ADDENDUM NO. 7

HVAC & CONTROLS REPLACEMENT/ADDITION AT NINE (9) SITES: BARRANCA, BEN LOMOND, CYPRESS, GROVECENTER, MANZANITA, MERWIN, MESA, ROWLAND, AND WORKMAN ELEMENTARY SCHOOLS RFQ/RFP #22-23-105

January 19, 2023

M1.1A

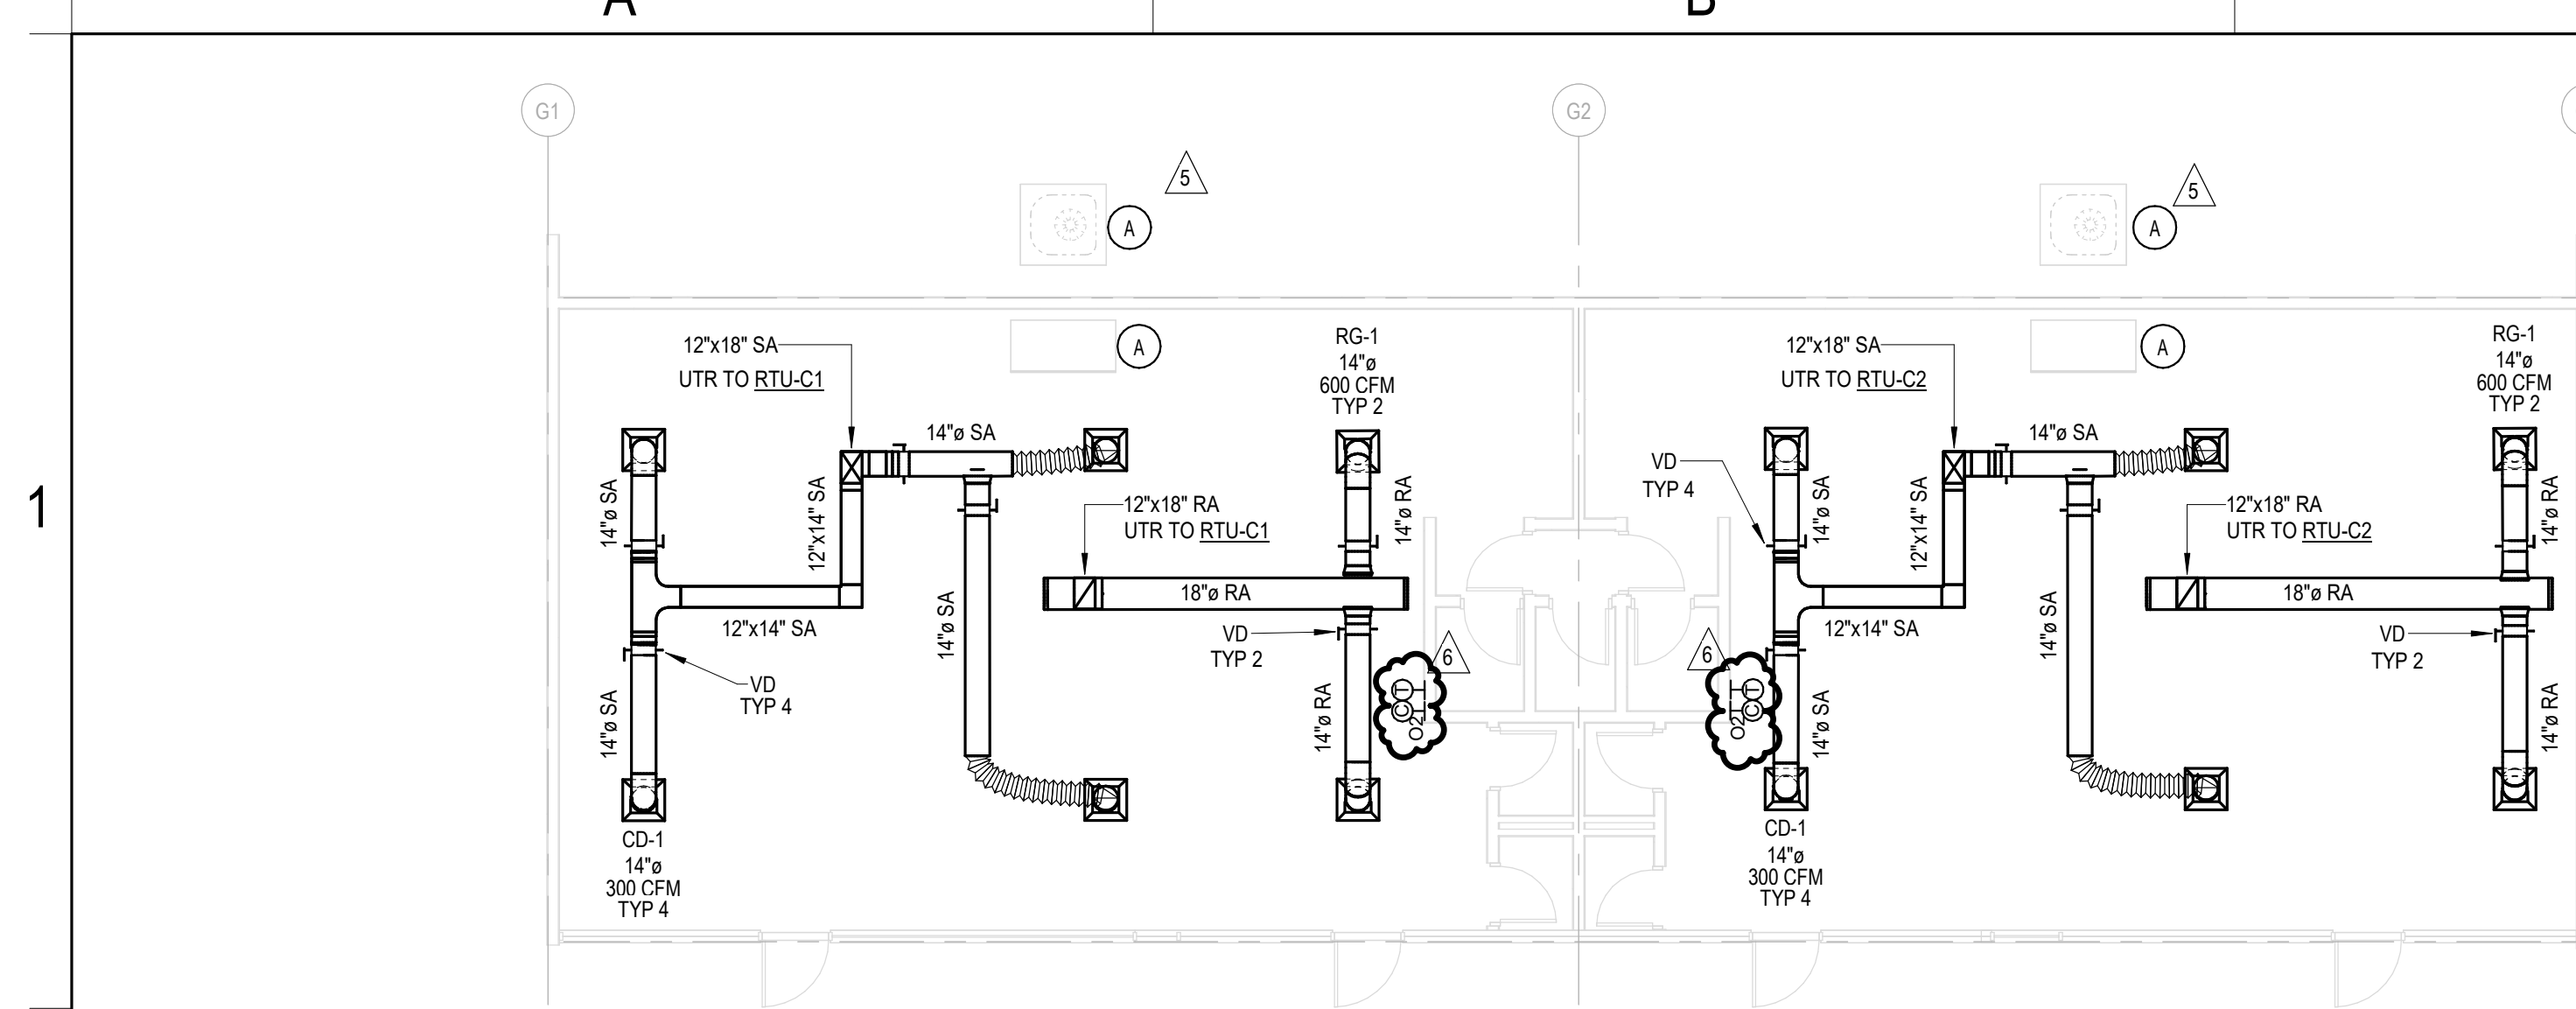
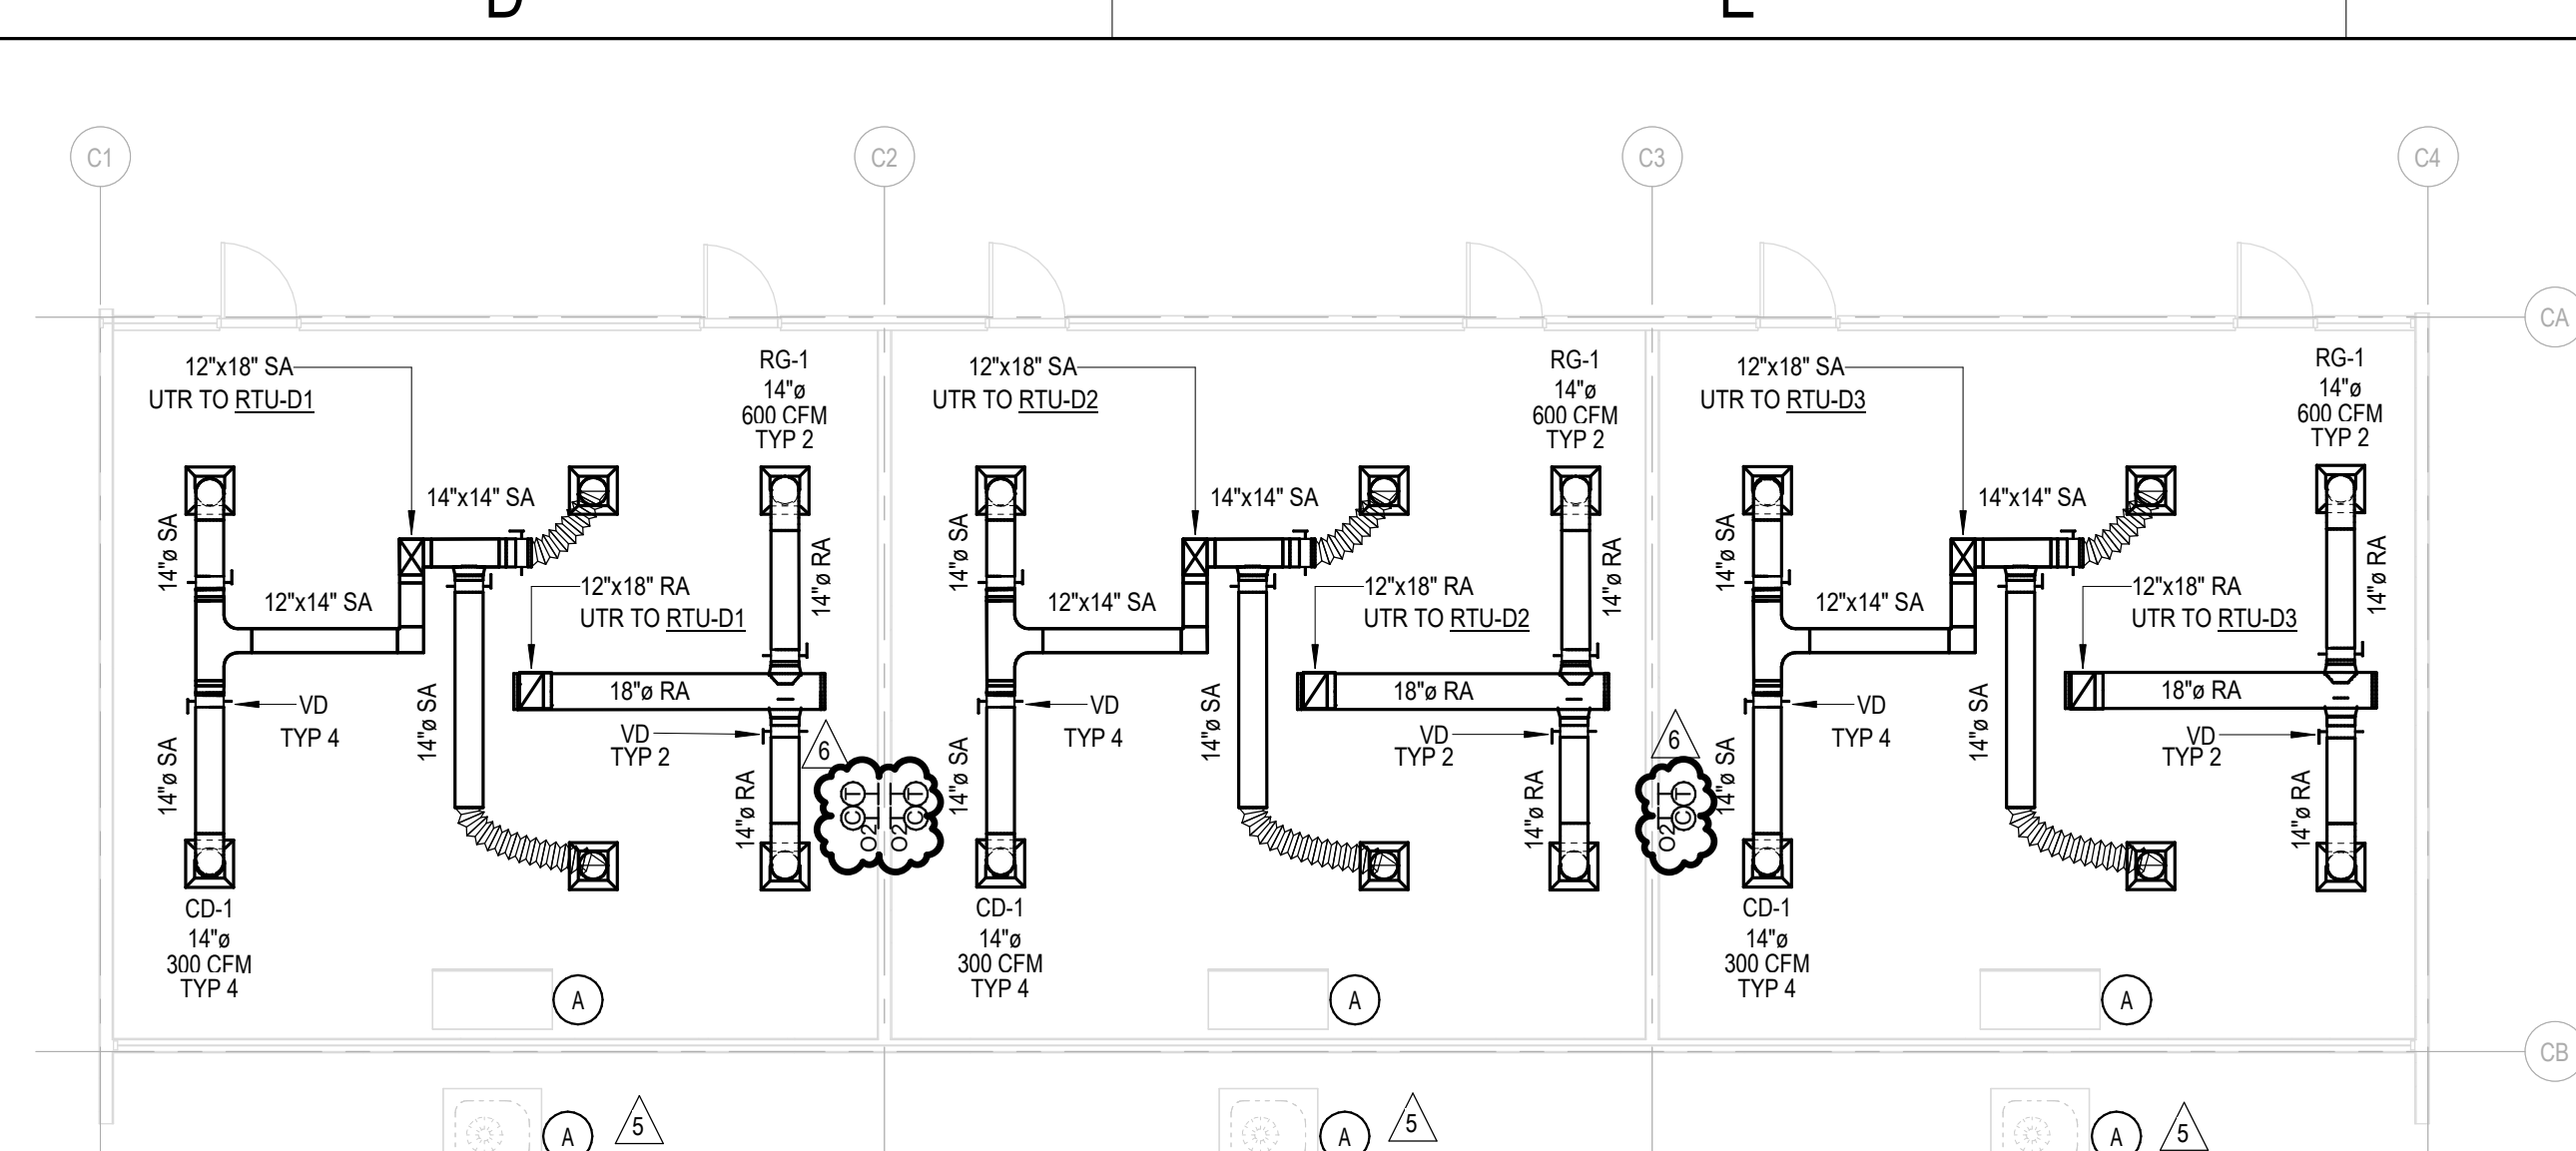
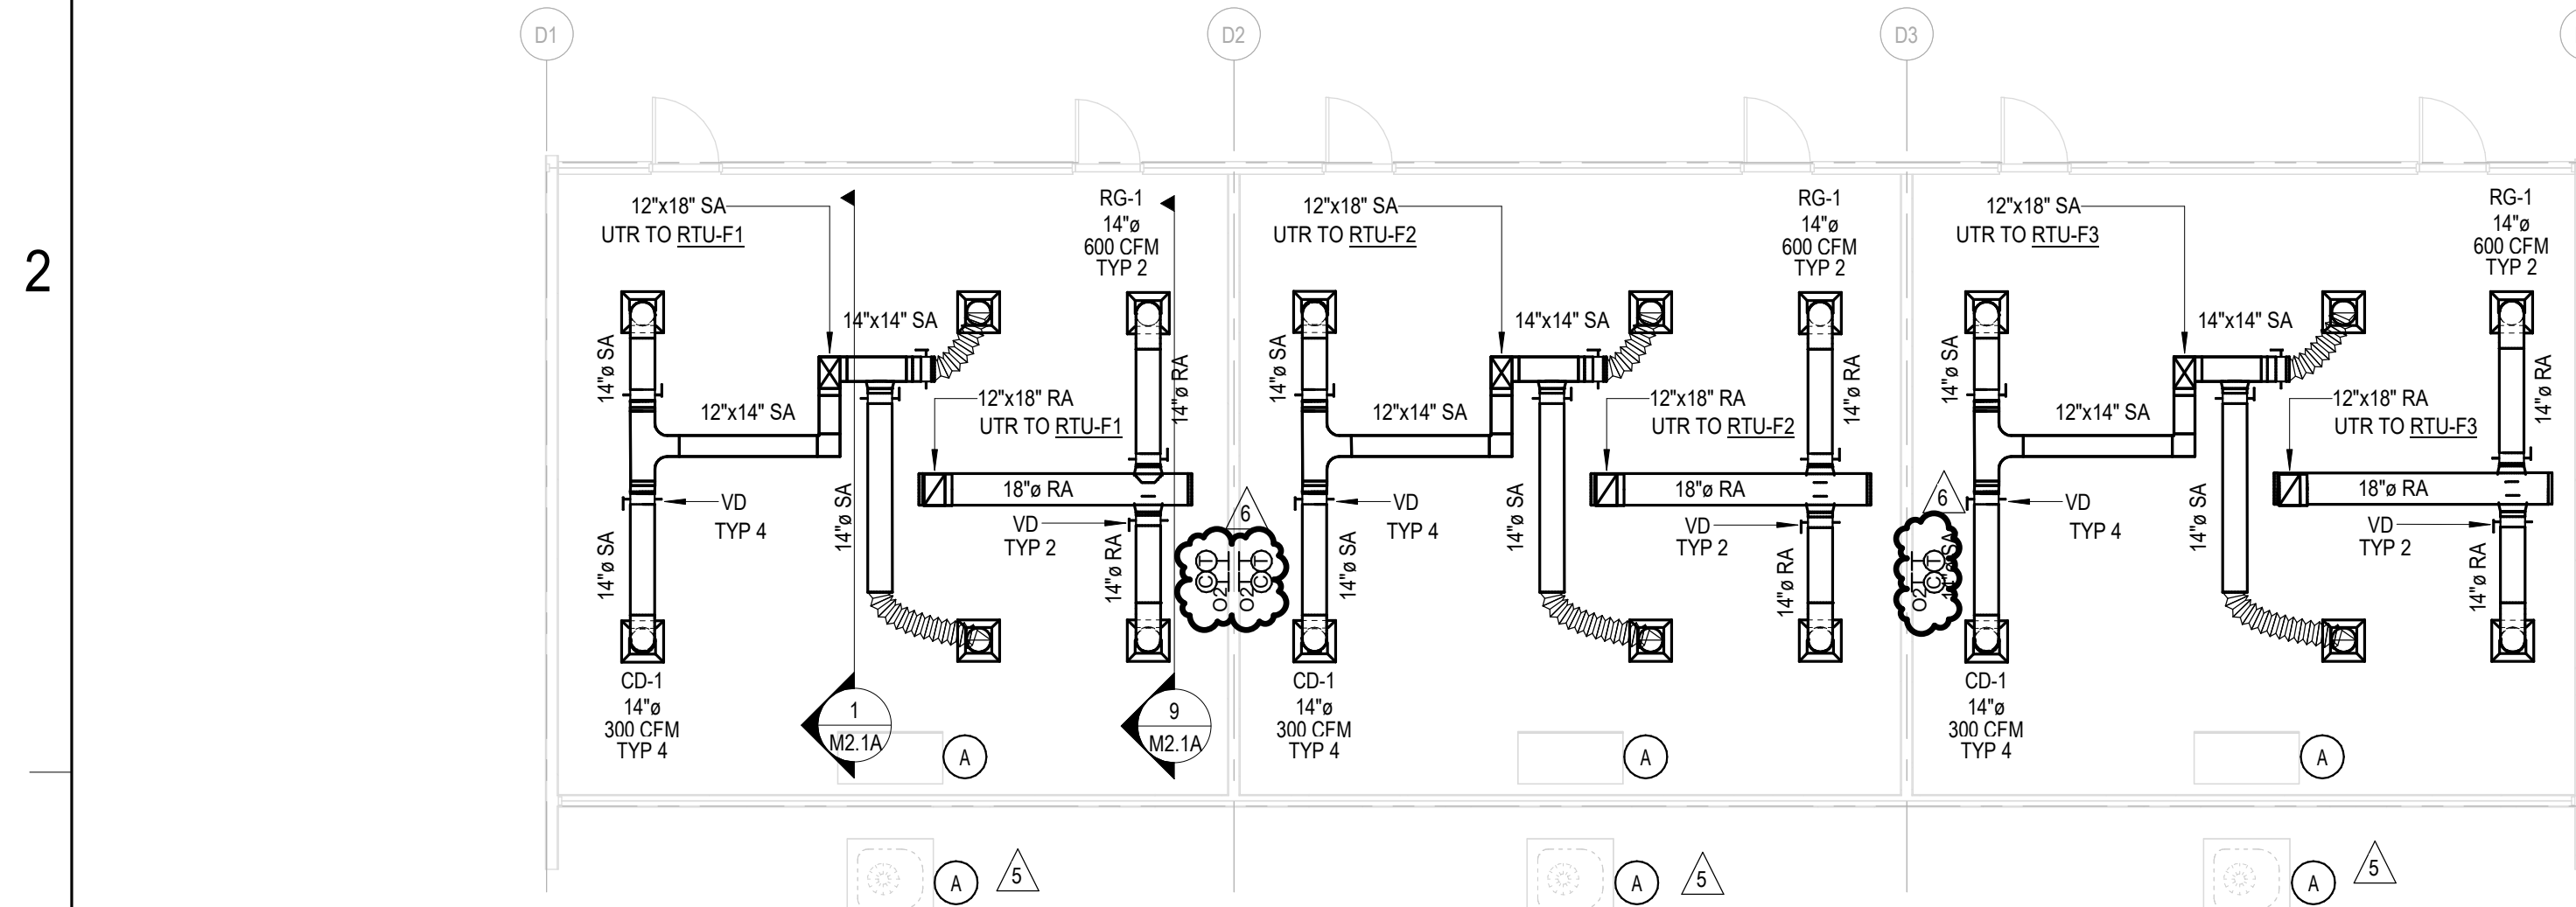
(Page M1.1A)

-Building H: RTU-H2 There is T stat locations on both walls on GL E2 and E3. Please confirm what wall the sensor is to be located.

DLR Response: See attached updated drawing M1.1A. Also, CO2 sensors are added in each classrooms same as the other schools.
